ADDENDUM NO. 2

Colton MS Pavilion Building Addition

Colton Joint Unified School District 1212 Valencia Drive Colton, CA 92324

RCA Project No. 1-15-112

215) SAWCUT EXISTING ASPHALT AND CONCRETE WITH A CLEAN EDGE. REMOVE AND DISPOSE EXISTING CONCRETE SIDEWALK. REMOVE AND DISPOSE OF 12" WIDE STRIP OF EXISTING ASPHALT, ADJACENT TO CONCRETE.

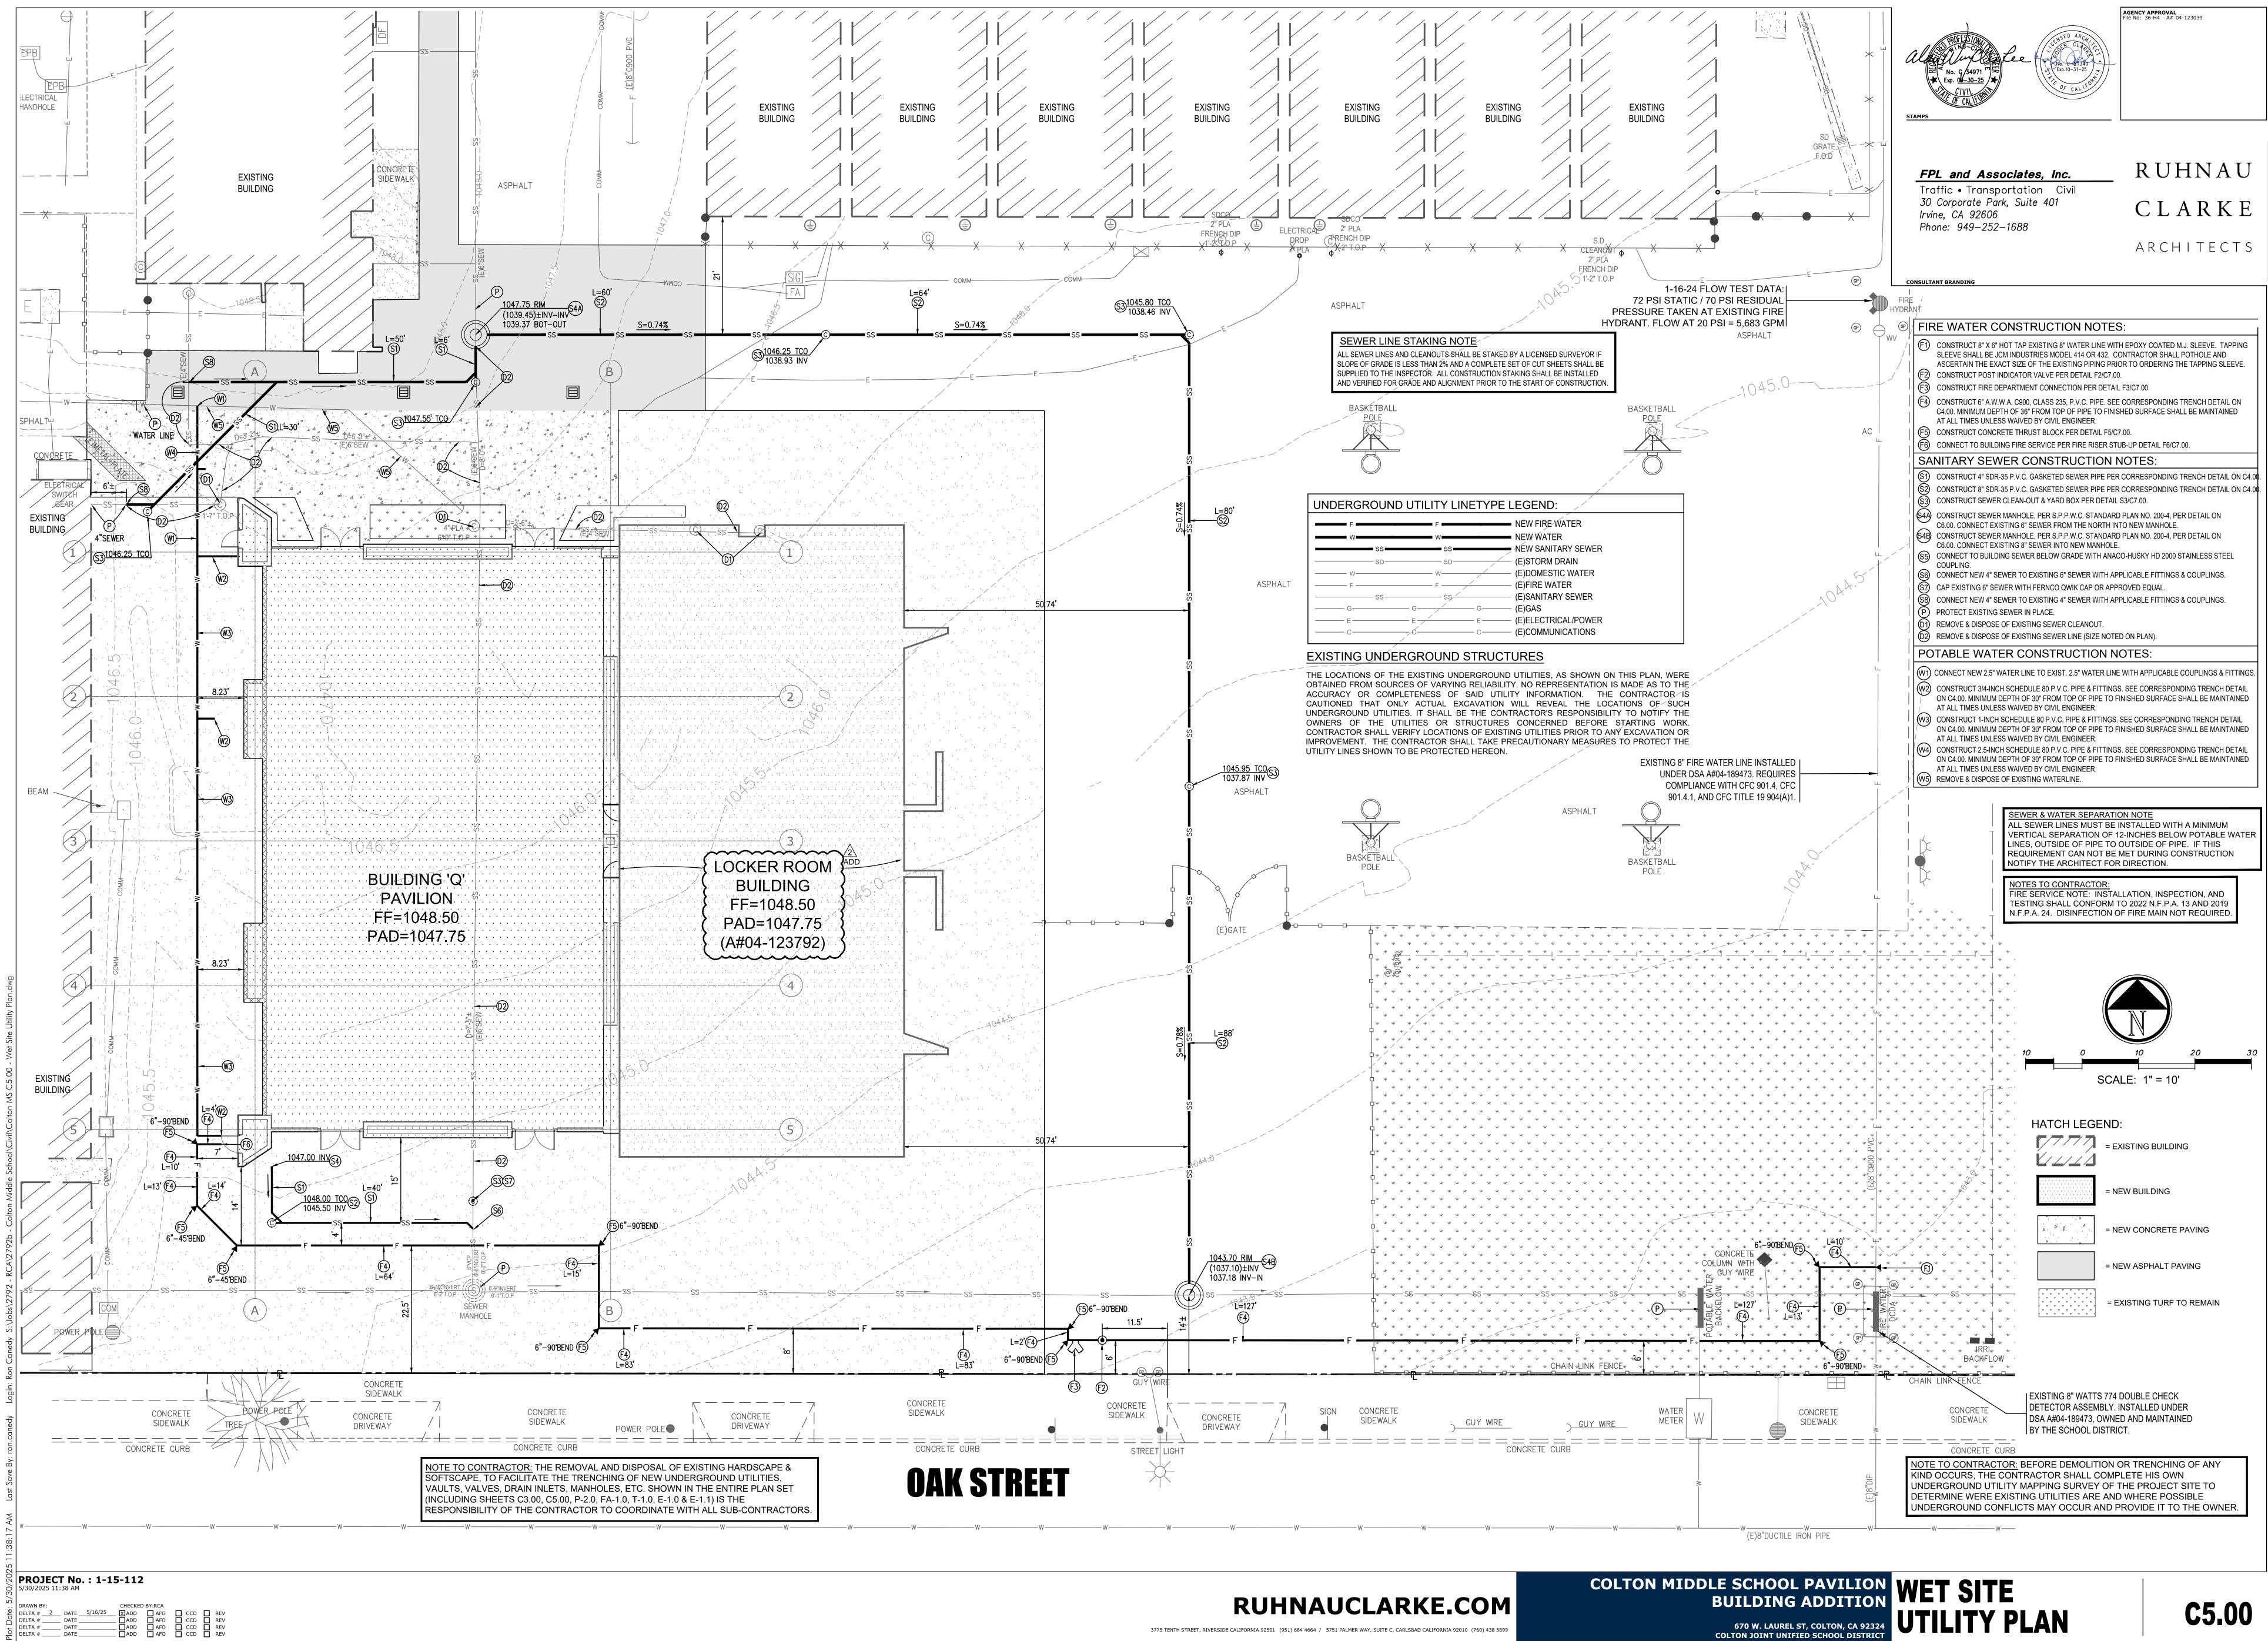
- Item No. 2.3 Reference sheet C2.00 DEMOLITION PLAN:
 - 2.3.1 Revise sheet C2.00 per clouded areas listed below.
 - a. Revised demolition note R4
 - b. Added note R4 to drawings at existing buildings
- Item No. 2.4 Reference sheet C3.00 GRADING PLAN:
 - 2.4.1 Revise sheet C3.00 per clouded area listed below.
 - a. Revised note locker room building

INTERIOR ELEVATION | 1/4" = 1'-0" | 2

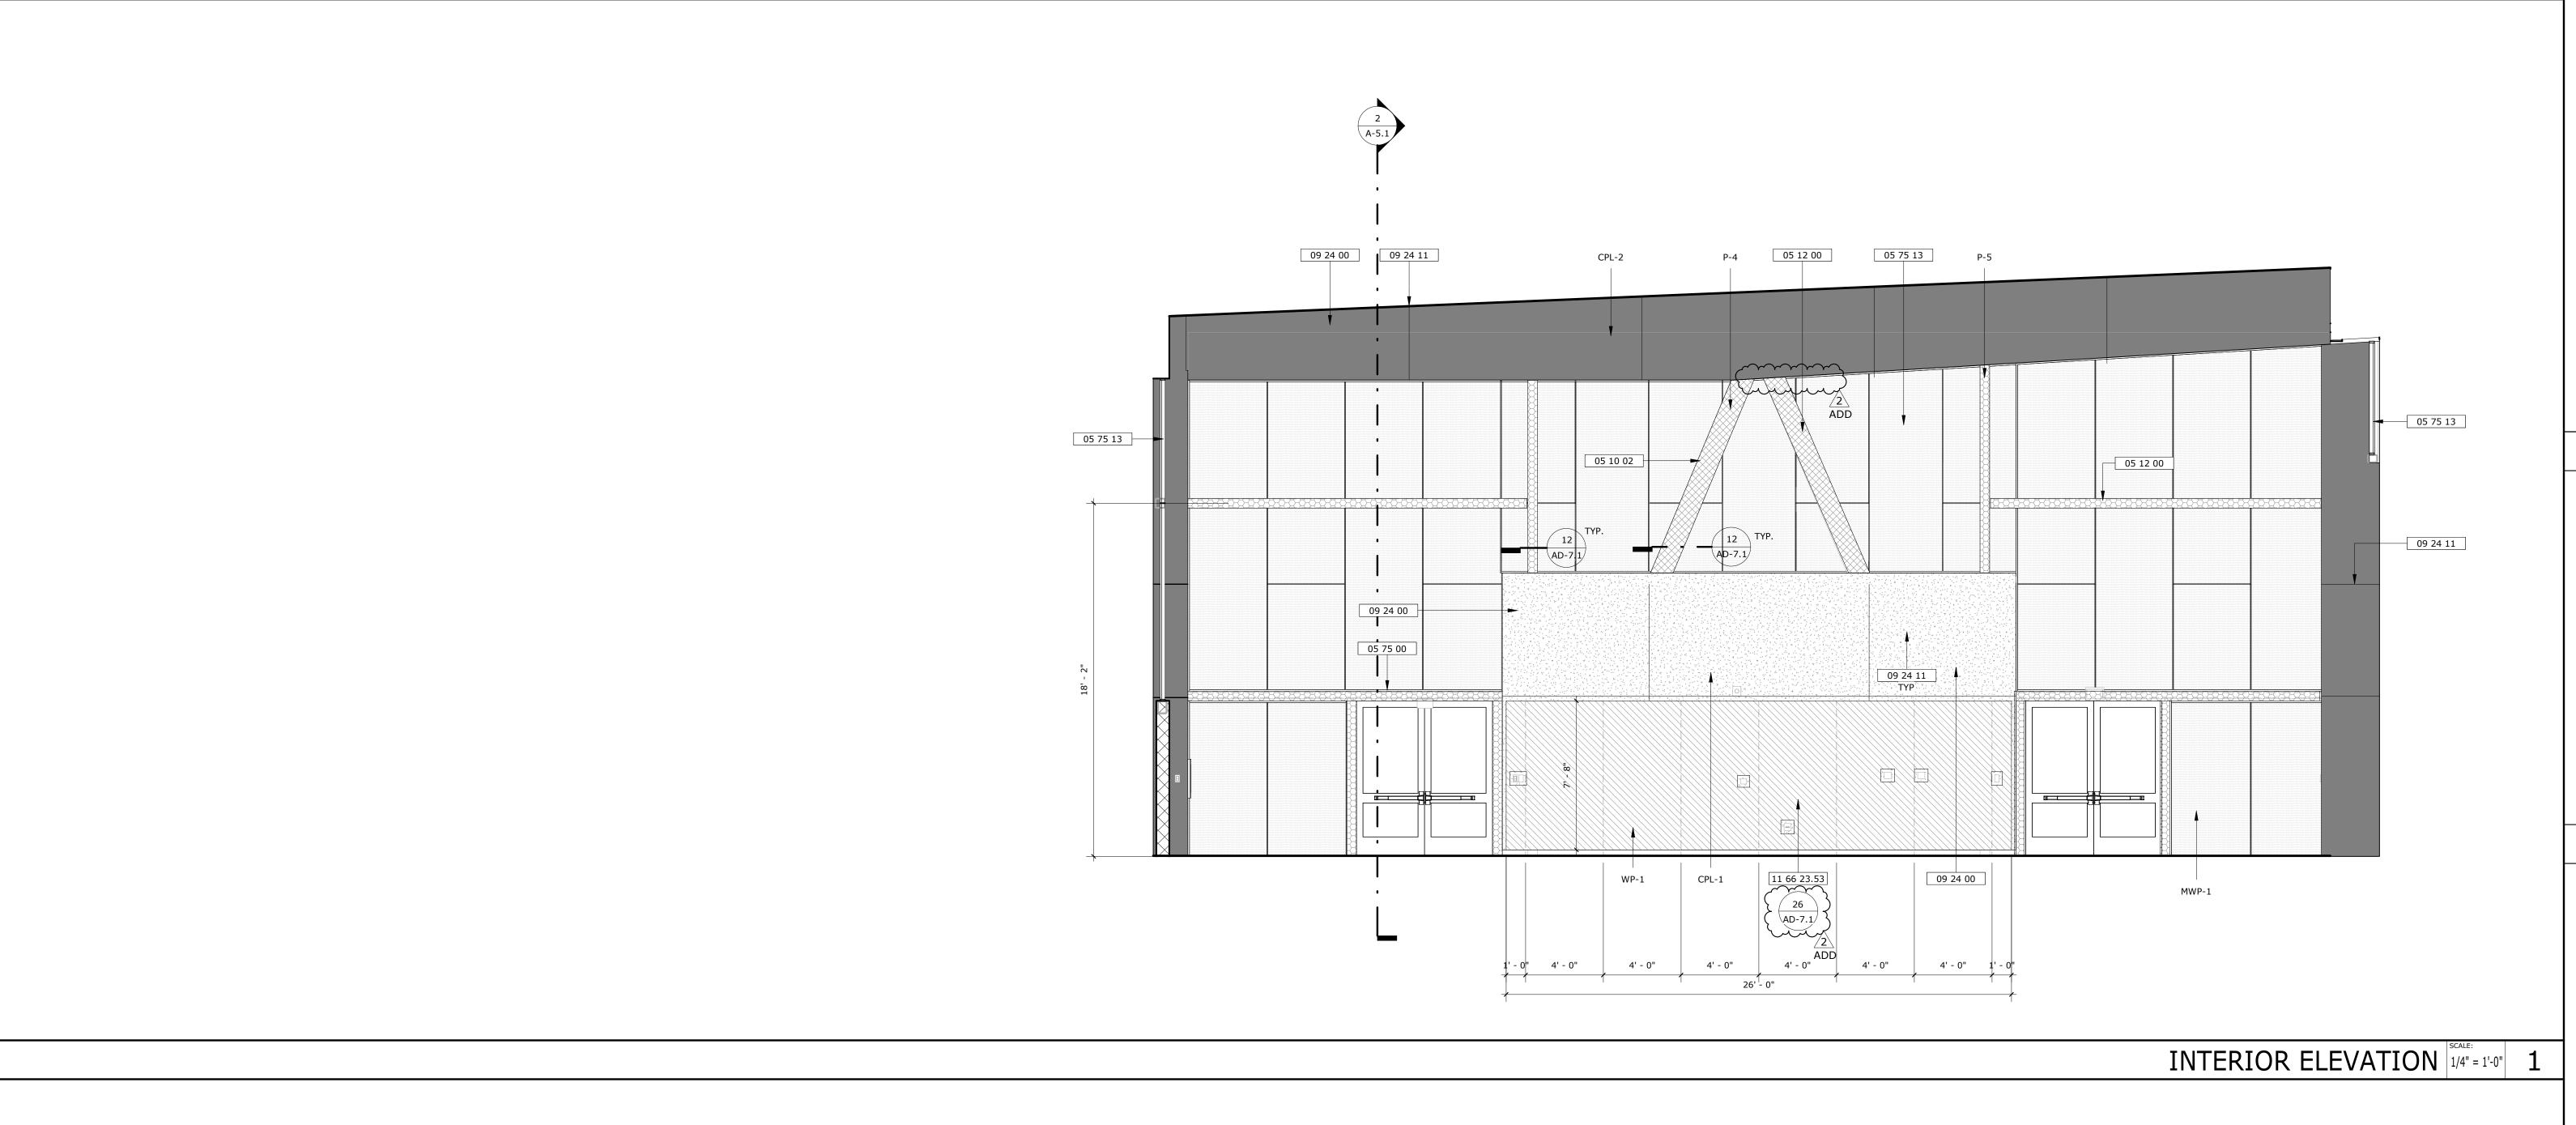
- Item No. 2.9 Reference sheet A-7.1 INTERIOR ELEVATIONS:
 - 2.9.1 Revise sheet A-7.1 per clouded areas listed below.
 - a. Revised detail 1/A-7.1 INTERIOR ELEVATION per clouded areas.
 - b. Revised detail 2/A-7.1 INTERIOR ELEVATION per clouded areas.
- Item No. 2.10 Reference sheet A-7.2 INTERIOR ELEVATIONS:
 - 2.10.1 Revise sheet A-7.2 per clouded areas listed below.
 - a. Revised detail 3/A-7.2 INTERIOR ELEVATION per clouded areas.
 - b. Revised detail 4/A-7.2 INTERIOR ELEVATION per clouded areas.
